Customer Name:		Gallien-Krueger		Current Rev #:		A1		New ECO Rev #:		A2	
Model:		Backline 250, 600, 115 Combo,		Distribute To:				Page:		1 Of: 2	
Assembly Description:		and 210 Combo		Originator:		Enrique Hernandez					
Assembly Numbers:		206-0181-A		Approved by:				Effective Date:		2/15/2005	
Effective				Document Update				Date		Initials	
<input checked="" type="checkbox"/>	All in Process	<input checked="" type="checkbox"/>	Next Buy	<input type="checkbox"/>	Artwork						
<input type="checkbox"/>	All in Service	<input checked="" type="checkbox"/>	Next Production Run	<input type="checkbox"/>	Assembly Dwg.						
<input checked="" type="checkbox"/>	All in Stock	<input type="checkbox"/>		<input type="checkbox"/>	Board Artwork						
Beginning Serial Number:				<input checked="" type="checkbox"/>	BOM						Noli
Reason For Change				<input type="checkbox"/>	Control Form						
Pre-Amp revoiced to sound more like the 400RB-IV.				<input checked="" type="checkbox"/>	Costing						TC

TITLE: BACKLINE 115 PREAMP
DRAWING NO: 406-0181-A
REV: A2

Customer Name:		Gallien-Krueger		Current Rev #:	A2	New ECO Rev #:	A3		
Model:		Backline 250, 600, 115 Combo, and 210 Combo		Distribute To:		Page:	1	Of:	2

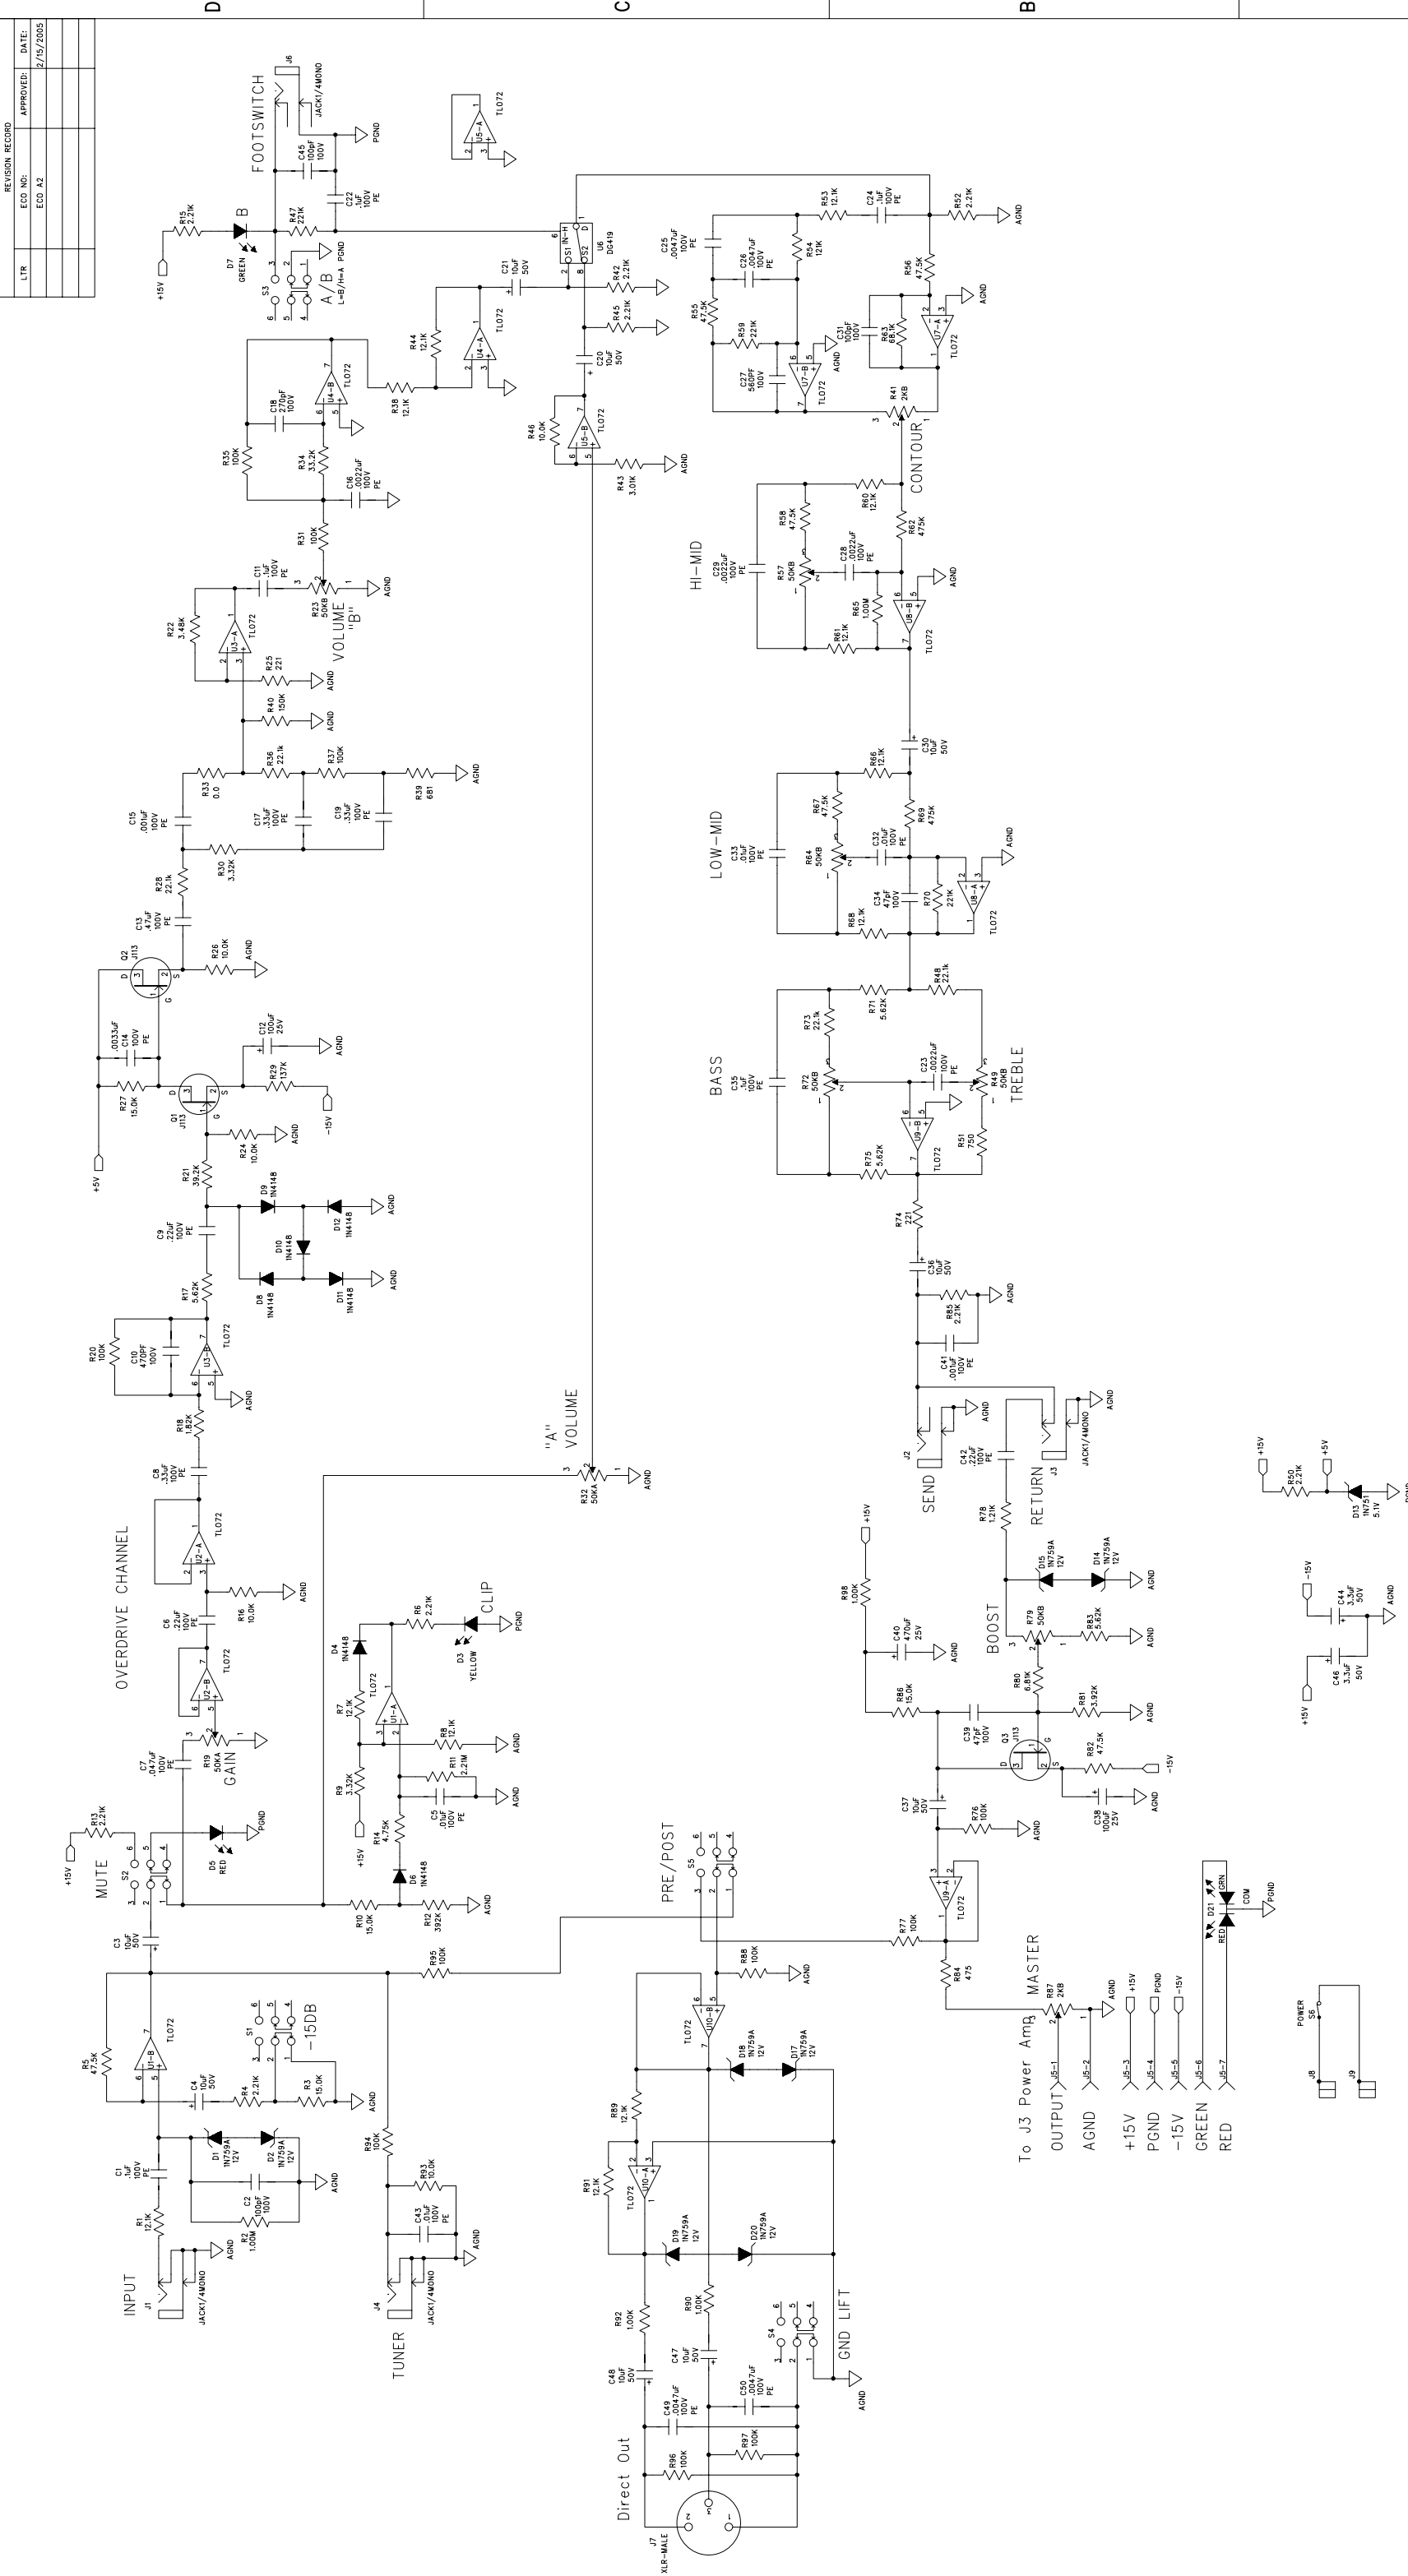
1. Changed resistor R48 from 5.62K to 22K.
2. Changed resistor R51 from 5.62K to 20K.
3. Changed resistor R52 from 47.5K to 68K.
4. Changed resistor R53 from 47.5K to 68K.
5. Changed resistor R54 from 47.5K to 22K.
6. Changed resistor R55 from 47.5K to 22K.

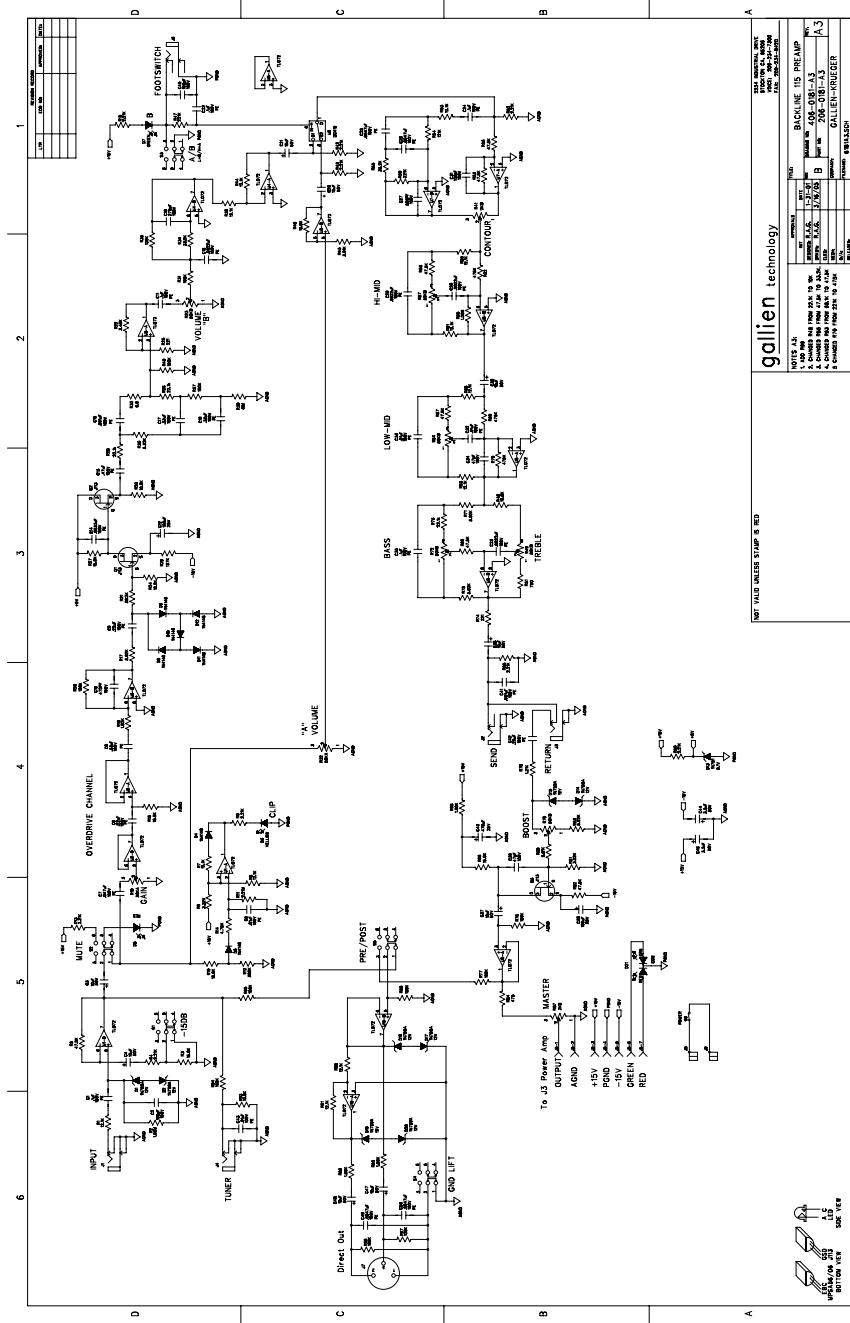
<input checked="" type="checkbox"/>	Incoming Q.C.				
Add a 47.5K resistor as well to bass and treble circuit that is missing, and should be there, it is designated R99 on the schematic 206-0181-A3.				<input type="checkbox"/>	Planning				
				<input checked="" type="checkbox"/>	Production Eng.				
				<input checked="" type="checkbox"/>	Purchasing				
				<input type="checkbox"/>	Q.A.				
				<input type="checkbox"/>	Receiving				
				<input type="checkbox"/>	Service				
				<input type="checkbox"/>	Test				
				<input type="checkbox"/>	Vendor				
				<input type="checkbox"/>					
				<input type="checkbox"/>					
<input type="checkbox"/>	Continued on ECO Supplement Page			<input checked="" type="checkbox"/>	Drawing(s) attached				
Part Number	Description	Parts Added		Parts Deleted					
		Qty	Ref. Designator	Qty	Ref. Designator				
060-2213-0	1/8W, 22.1K			1	R48				
060-1752-0	1/8W, 47.5K			1	R55

TITLE: BACKLINE 115 PREAMP
REV: 1-01
DATE: 3/18/03
DRAWN: R.A.G.
ELEC: B
PART NO: 206-0181-A4
COMPANY: GALLIEN-KRUEGER
RELEASED: 2/1/03
ITEM: 6181A4.SCH

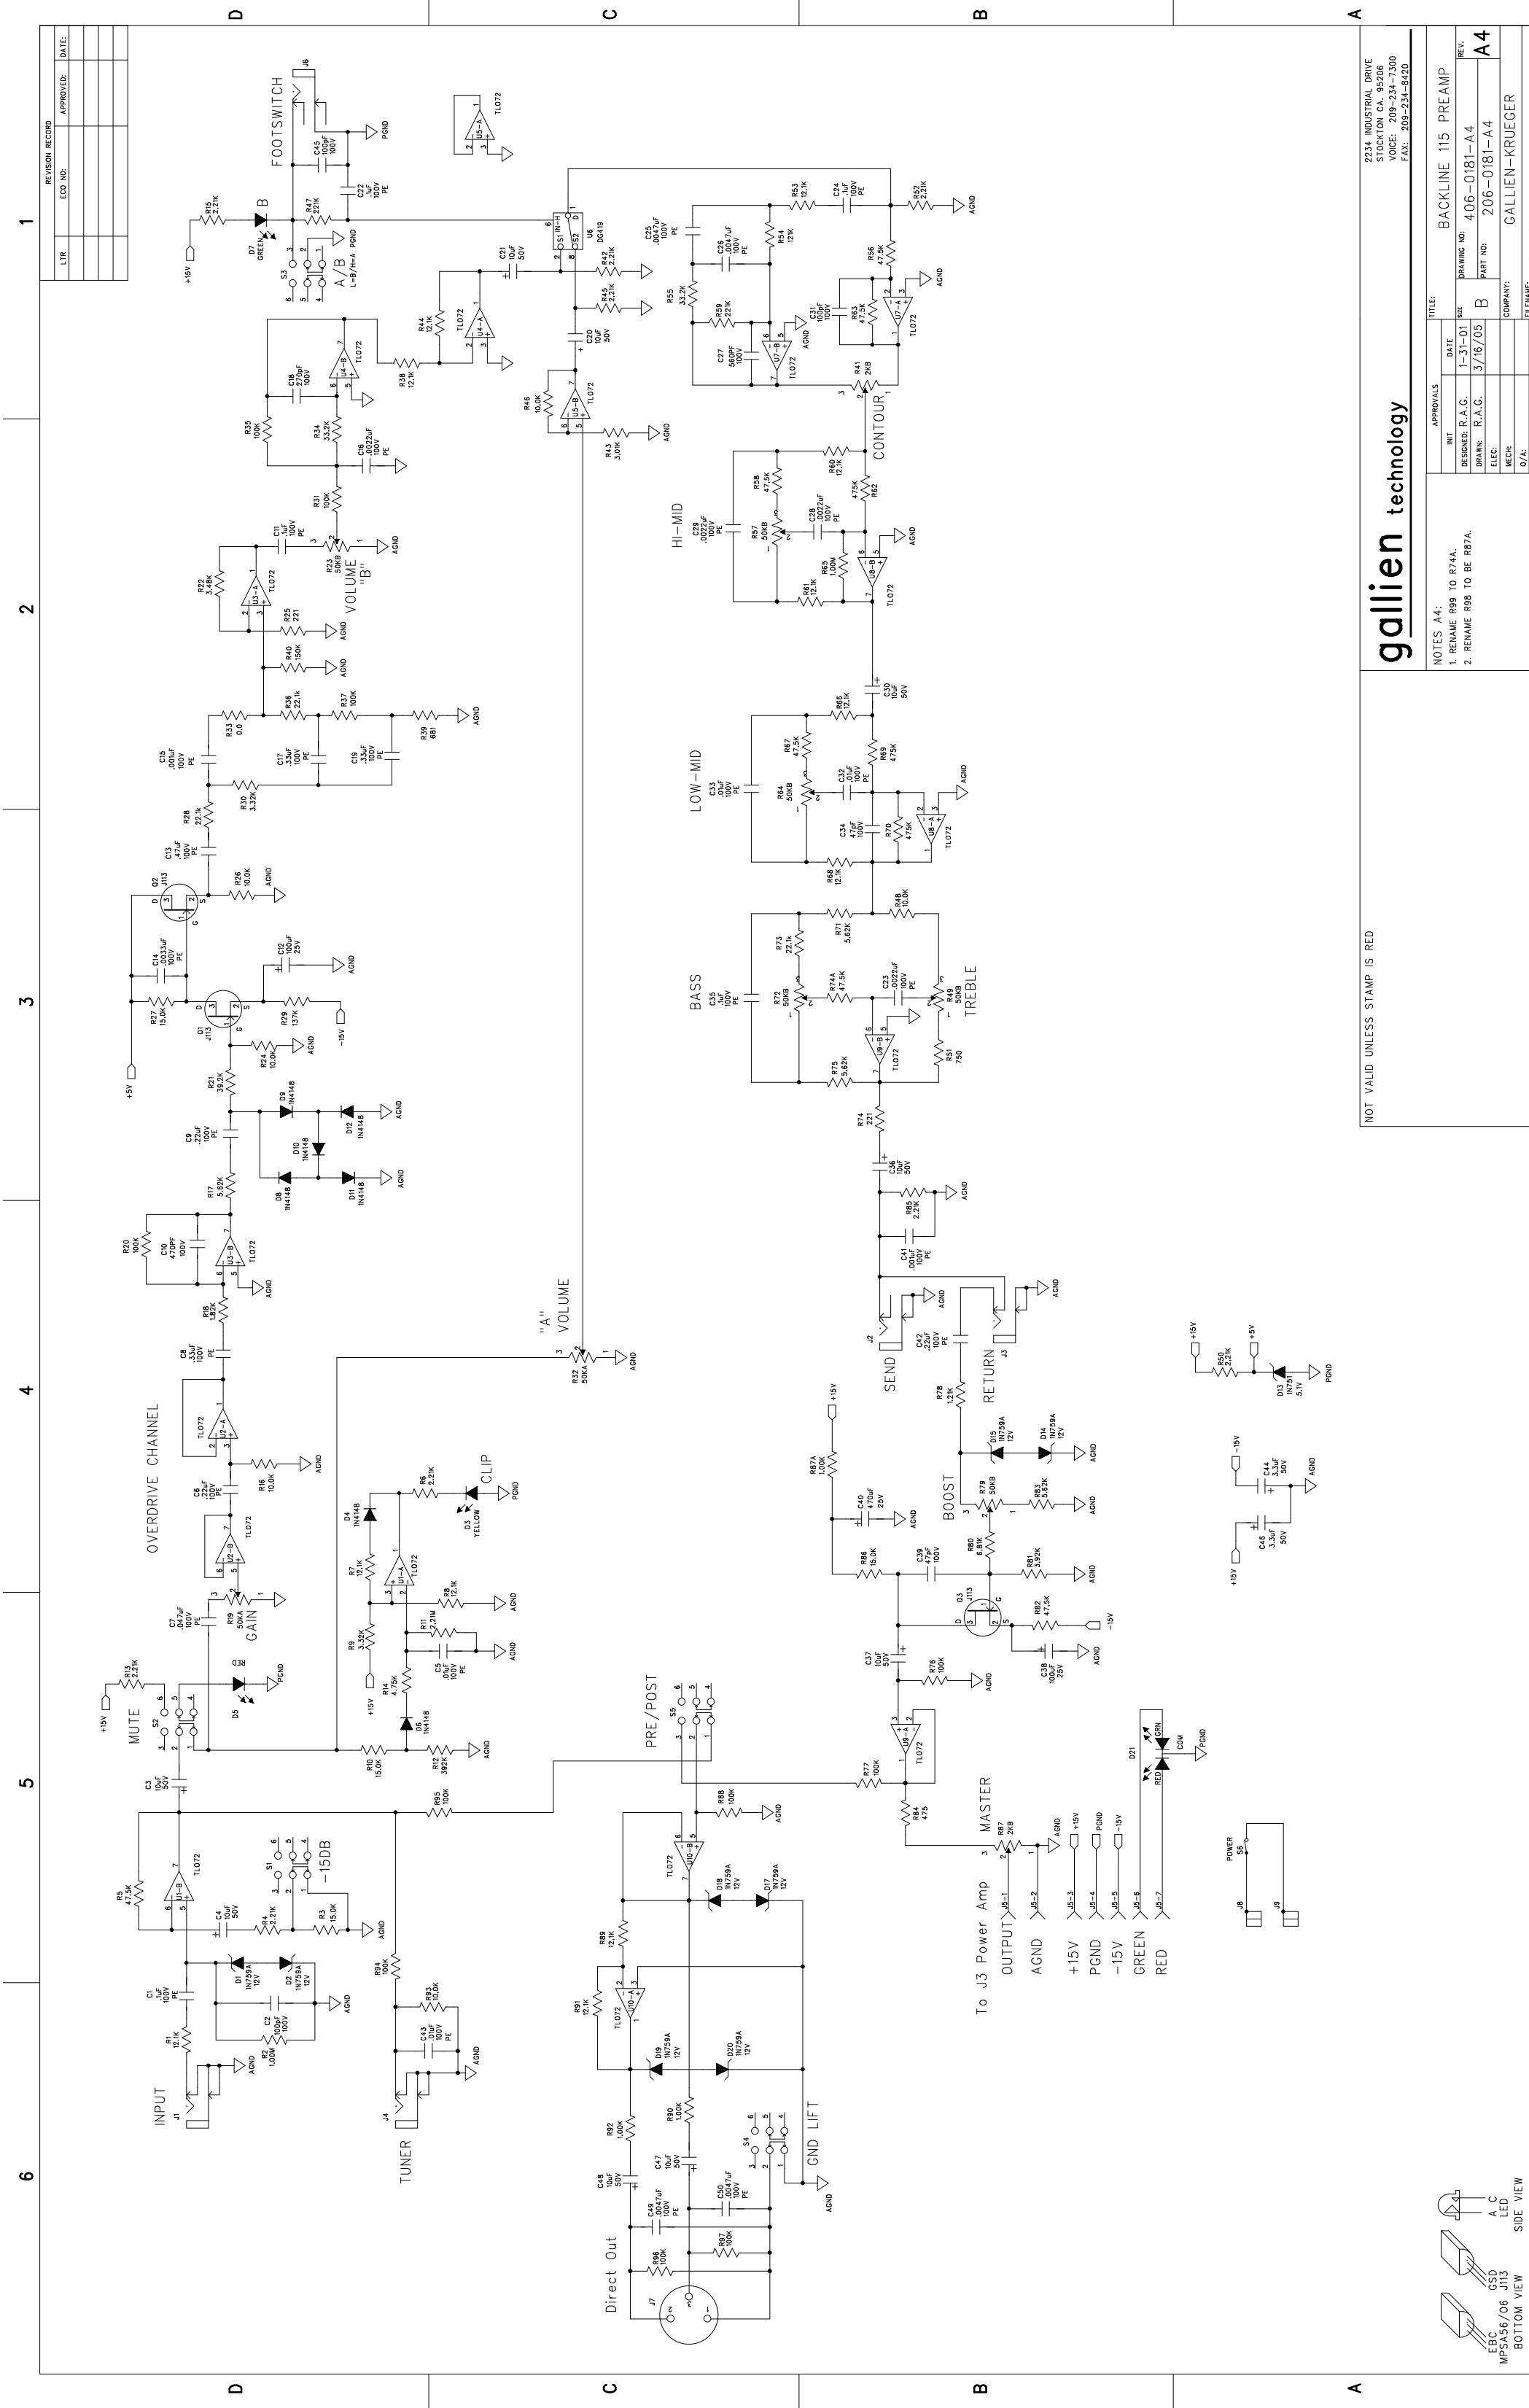
<input type="checkbox"/>	Planning						
Resistor R98 changed to R87A, and resistor R99 changed to R74A.				<input checked="" type="checkbox"/>	Production Eng.						
				<input checked="" type="checkbox"/>	Purchasing						
				<input type="checkbox"/>	Q.A.						
				<input type="checkbox"/>	Receiving						
				<input type="checkbox"/>	Service						
				<input type="checkbox"/>	Test						
				<input type="checkbox"/>	Vendor						
				<input type="checkbox"/>							
				<input type="checkbox"/>							
				<input checked="" type="checkbox"/>	Drawing(s) attached						
Part Number		Description		Parts Added				Parts Deleted			
				Qty	Ref. Designator			Qty	Ref. Designator

NOTES A4:
1. RENAME R98 TO R74A.
2. RENAME R98 TO BE R74A.
